Work Order ID 126226

Item Name: Strut

ENGINEERING CHANGE NOTICE NO.

DWG NO. 646.3500

SHEET 1, ZONE A1 IS:

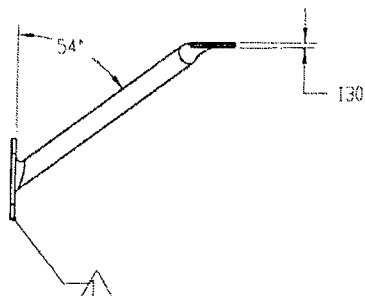
REASON: REVISED DELTA NOTE 1 & 2.

- 1 MATERIAL: AISI 304/ 316 SS SHEET .062 THK
(REF DART SPEC. M304S16GA)
- 2 MATERIAL: AISI 304/316 SS 0.500 OD X 0.049 WALL
(REF DART SPEC. M304TRO.500W0.049)
ENSURE SEAMLESS TUBE IS USED
- 3 FINISH: HARD ANODIZE IAW MIL-A-8625 TYPE III, CLASS 2
COLOR BLACK;
CARDINAL 4860-50 PRETREATMENT PRIMER
PRIME IAW MIL-P-23377J TYPE I CLASS N
4. DEBURR AND BREAK ALL SHARP EDGES
5. WELDS IAW MIL-STD-2219.
TIG WELD WITH FILLER ROD

SHEET 2 IS:

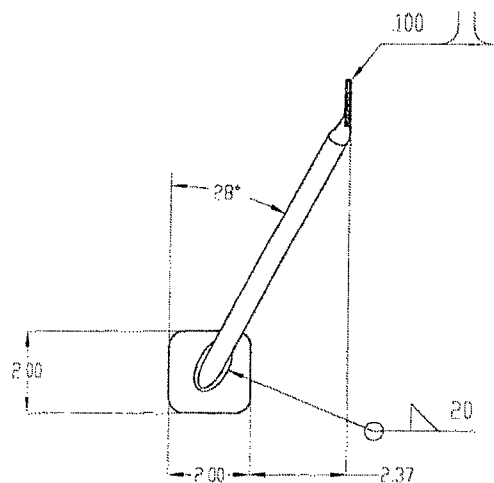
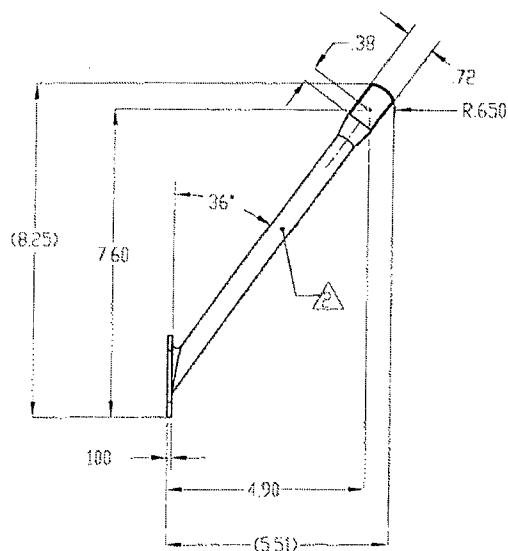
ENGINEERING CHANGE NOTIC. NO. 02440		SHEET 1 OF 1	
DWG NO. 646.3500	REV: NC	PREPARED BY S. HUFF	DATE 06/08/09
DWG TITLE: STRUT		EFFECT ON DWG ☐ INC. ☒ UNINC.	
APPROVED BY: ENGR <i>[Signature]</i>	MFG <i>[Signature]</i>	QC <i>[Signature]</i>	EFF: CURRENT ORDER AND STOCK
REASON: REVISED GEOMETRY TO ACCOMMODATE NEW EXISTING AIRCRAFT PROVISIONS

646.3512 SHOWN
646.3513 OPPOSITE

SHEET 2, IS:

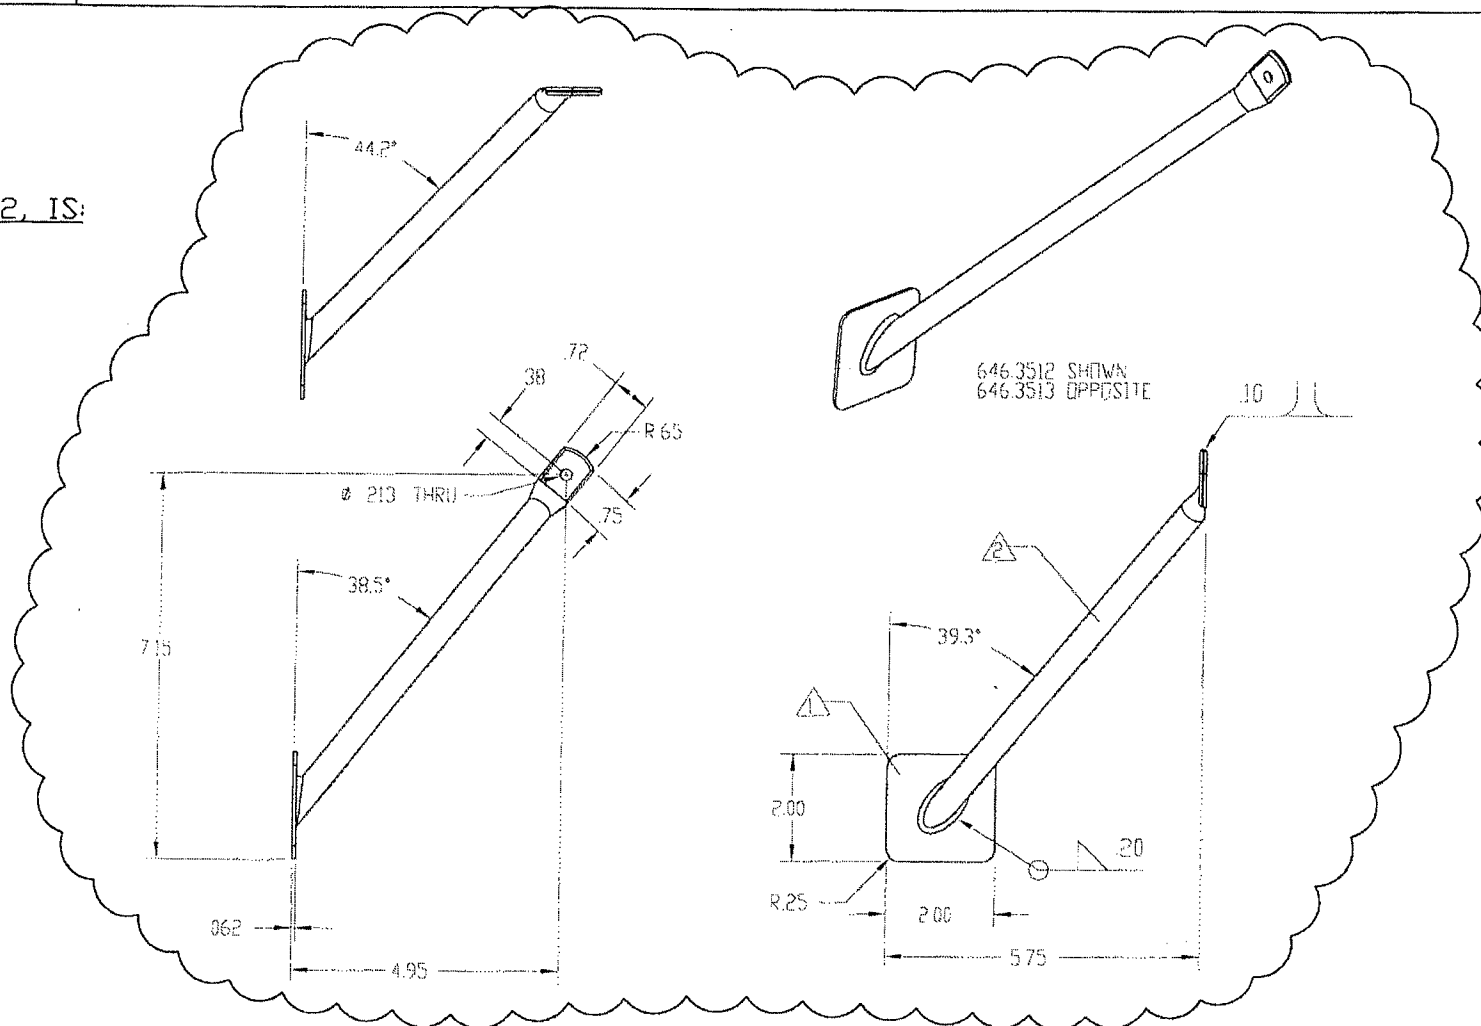
REASON: REVISED ANGLE OF 646.3512 & 646.3513 FOR BETTER FITMENT
